TAX ID # 05-357225
ON-SITE SEWAGE DISPOSAL SYSTEM
HOWARD COUNTY HEALTH DEPARTMENT
BUREAU OF ENVIRONMENTAL HEALTH

SUBDIVISION: CISSEL FARM - SEC 3 LOT NUMBER: 36

ADDRESS: 7017 DEER VALLEY DR PROPERTY OWNER: FLORA STRUB

Gabe Creighton, Sanitarian
Well and Septic Program
Percolation Testing, A526711
Mrs. Flora Strub
7017 Deer Valley Dr.
Highland, MD 20777

Lot # 36
 2.205 Acres
 Liber 432
 folio 240

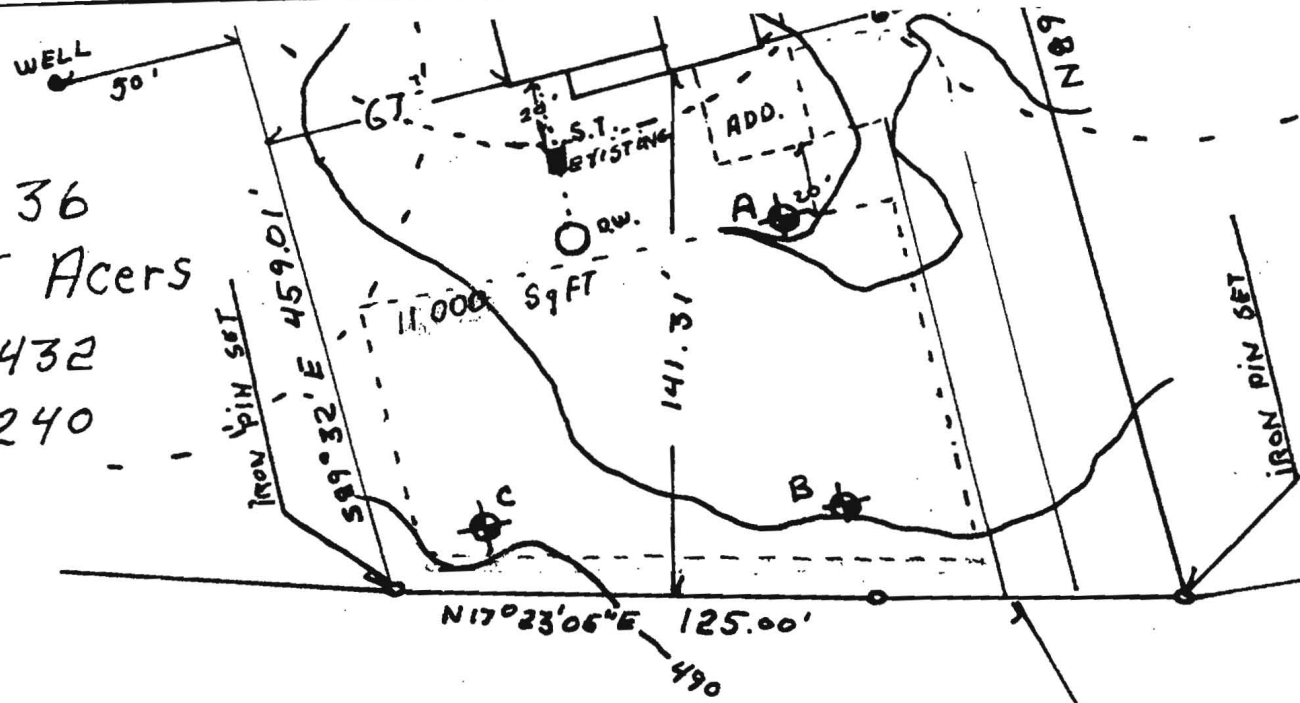
upgrade notes:
 ex. Septic tank ~ 10' (inlet)
 below grade ex. drywell ~
 8-10' (inlet depth) must be
 abandoned. House to be re-
 plumbed to allow new septic
 to be suitable depths. ejector
 will be needed in bgnst.
 Basement not approved for
 gravity. Addition may enter
 S.T. on separate line from
 house. **GAC**
